City of Portland Historic Landmarks Commission

Design Advice Request

SUMMARY MEMO

Date: April 8, 2019
To: Kurt Schultz | SERA Architects
From: Grace Jeffreys, Design and Historic Resource Review
503-823-7840 | grace.jeffreys@portlandoregon.gov
Re: EA 19-110899 DA – Galleria Penthouse, 600 SW 10th
Design Advice Request Commission Summary Memo – March 25, 2019 Meeting

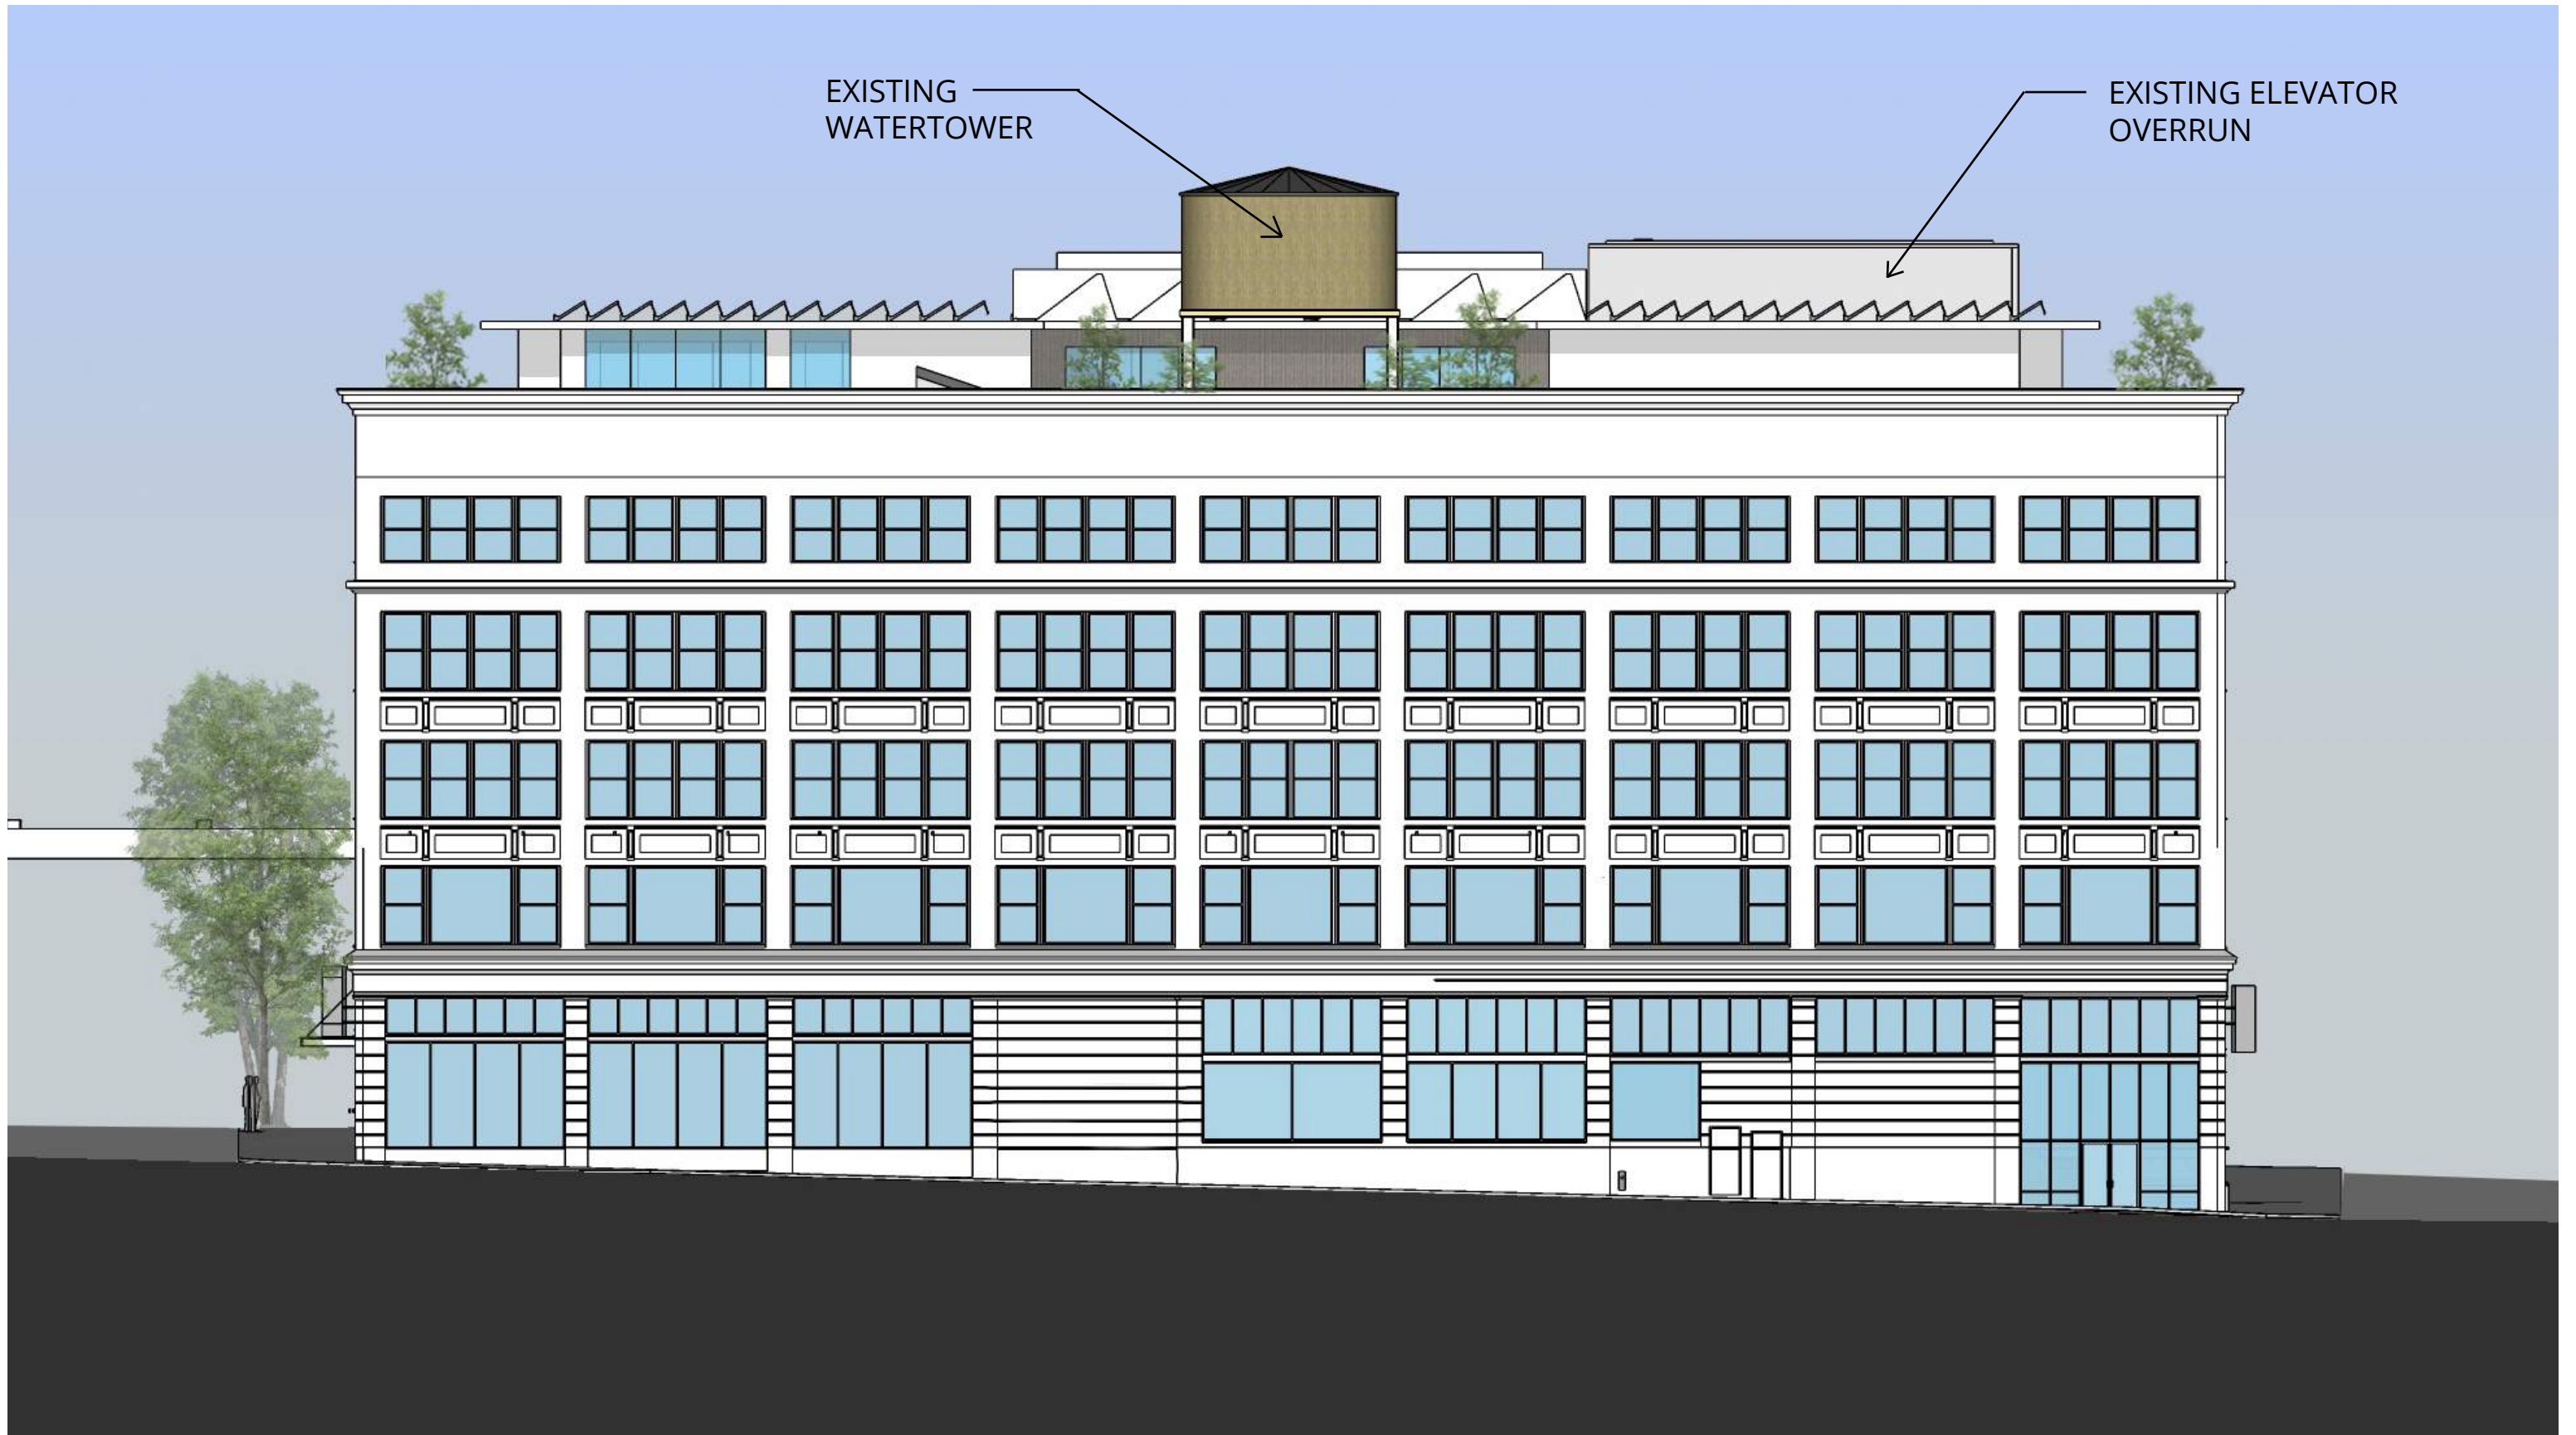
- 3. New mechanical area.** (*Guidelines HAC 8, 9, CCFDG C3, C4, C5, C11*). The intention is to replace existing mechanical systems with a new, much smaller central mechanical system on the new penthouse roof, set back from the building edges and screened.

The Commission agreed the consolidation and reduction of mechanical would be a welcome improvement over the existing conditions and supported the proposed central location and approach to screening. They noted the screening material should relate to the cladding below, and the mechanical area should be designed large enough to accommodate future needs, which are unknown.

- 4. Solar.** (*Guidelines HAC 8, 9, CCFDG C3, C4, C5, C11*). Solar panels are shown on the rooftops.

The Commission noted that eco-roofs would provide a more overall positive addition to the surrounding area through stormwater runoff, adding nature to the city, and improving views from the rooftops from above. They also noted concern that extensive photovoltaics could cause glare to surrounding structures above. There would be support for a mix of both.

Ensure the materials are of a high quality and used in a coherent manner. The glazed curtain walling between piers is supportable. The Commission encouraged cladding the piers with a material that references the terra cotta, such as one with a light enameled finish with a comparable sheen but is differentiated by being a modern material. Carry on the same material to the mechanical screen. Look also at improving the elevator overrun.
